Access Compliance Report

Public Rights-of-Way

(Curb Ramps)

Intersection ID: 14442	Main Street: N_SHARON_AMITY_RD	Cross Street: CENTRAL_AV	Location: SW
ADA ID: 1D9A8C8D032E	Ramp Type: BlendTrans1	Initial Pass/Fail: Fail	Overall Compliance: No
		Severity Score: 8.75

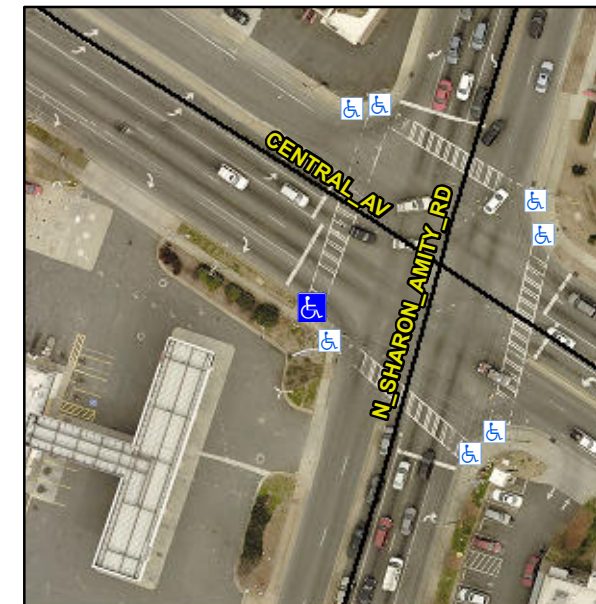
Not Found, R304.5.1

Compliance	Description	Data	Compliance	Description	Data
N/A	Ramp Length (in)	69.0	Yes	BlendTrans Slope (%)	2.4
No	Ramp Width (in)	42.5	Yes	BlendTrans XSlope (%)	1.1
N/A	Flare Type LT	N/A	N/A	Flare Type RT	N/A
N/A	Flare Slope LT (%)	N/A	N/A	Flare Slope RT (%)	N/A
N/A	Flare Traversable LT?	N/A	N/A	Flare Traversable RT?	N/A
N/A	Landing Length (in)	N/A	N/A	DWS Provided?	N/A
N/A	Landing Width (in)	N/A	N/A	DWS Contrast?	N/A
N/A	Landing Slope (%)	N/A	N/A	DWS Length (in)	N/A
N/A	Landing X Slope (%)	N/A	N/A	DWS Full Width?	N/A
N/A	Landing Curb? (Y/N)	N/A	N/A	DWS Offset (in)	N/A
N/A	Shared Landing?	N/A			
N/A	Gutter Ponding?	N/A	N/A	Gutter Slope (%)	N/A
N/A	Gutter Lip Ht (in)	N/A	N/A	Gutter X Slope (%)	N/A
N/A	Painted X Walk1?	Yes	N/A	Painted X Walk2?	N/A
	X Walk 1 Direction	To NE		X Walk 2 Direction	N/A
	X Walk 1 Width (in)	105.0		X Walk 2 Width (in)	N/A
	X Walk 1 Slope (%)	1.6		X Walk 2 Slope (%)	N/A
	X Walk 1 X Slope (%)	1.0		X Walk 2 X Slope (%)	N/A

N/A	Ramp inside XWalk1?	Yes	N/A	Ramp inside XWalk2?	N/A
	Road Slope (%)	1.0		Clear Space?	N/A
	Road X Slope (%)	1.6	N/A	Clear Space to XWalk (in)	N/A
N/A	Any Obstructions?	N/A	N/A	Storm Grate/Utility Hazard?	N/A
	Obstruction Type			Storm Grate/Utility Type	
		N/A			N/A
			Yes	Surface Condition? (G/P)	Good
			No	Curb Slope (%)	30.9

Remove & Replace Curb Ramp With Two New Directional Ramps or Equivalent.
